Access Compliance Report

Public Rights-of-Way

Intersection ID: 13718	Main Street: E_7TH_ST	Cross Street: PARK_DR	Location: S
ADA ID: C3C4D4E3C7BE	Ramp Type: Directional1	Initial Pass/Fail: Fail	Overall Compliance: No
		Severity Score: 12.5

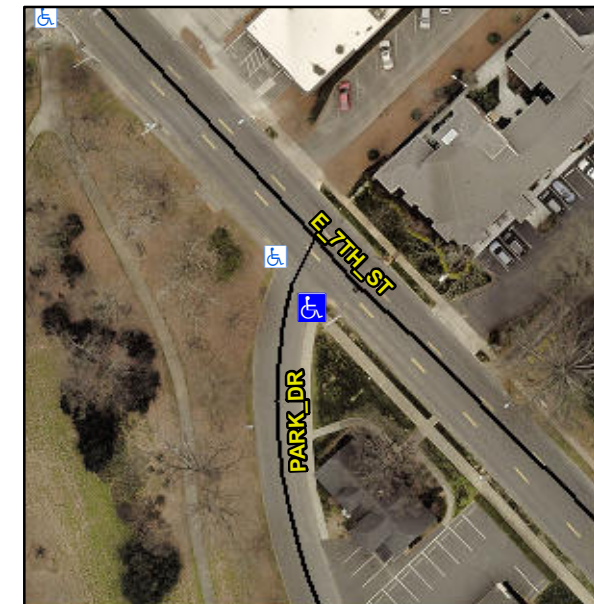
R304.2.2

Compliance	Description	Data	Compliance	Description	Data
N/A	Ramp Length (in)	43.0	N/A	Grade Break?	N/A
Yes	Ramp Width (in)	59.0	N/A	Grade Break Slope (%)	0.0
No	Ramp Slope (%)	10.1	N/A	Grade Break XSlope (%)	0.0
Yes	Ramp XSlope (%)	0.5			
N/A	Flare Type LT	N/A	N/A	Flare Type RT	N/A
N/A	Flare Slope LT (%)	N/A	N/A	Flare Slope RT (%)	0.0
N/A	Flare Traversable LT?	N/A	N/A	Flare Traversable RT?	N/A
N/A	Landing Length (in)	0.0	N/A	DWS Provided?	N/A
N/A	Landing Width (in)	0.0	N/A	DWS Contrast?	N/A
N/A	Landing Slope (%)	0.0	N/A	DWS Length (in)	N/A
N/A	Landing X Slope (%)	0.0	N/A	DWS Full Width?	N/A
N/A	Landing Curb? (Y/N)	N/A	N/A	DWS Offset LT (in)	N/A
N/A	Shared Landing?	N/A	N/A	DWS Offset RT (in)	N/A
N/A	Gutter Ponding?	0.0	N/A	Gutter Slope (%)	N/A
N/A	Gutter Lip Ht (in)	0.0	N/A	Gutter X Slope (%)	N/A
N/A	Painted X Walk1?	No		Road Slope (%)	0.1
	X Walk 1 Direction	To NW		Road X Slope (%)	1.3
	X Walk 1 Width (in)	N/A		Clear Space?	N/A

Remove & Replace Entire Ramp.
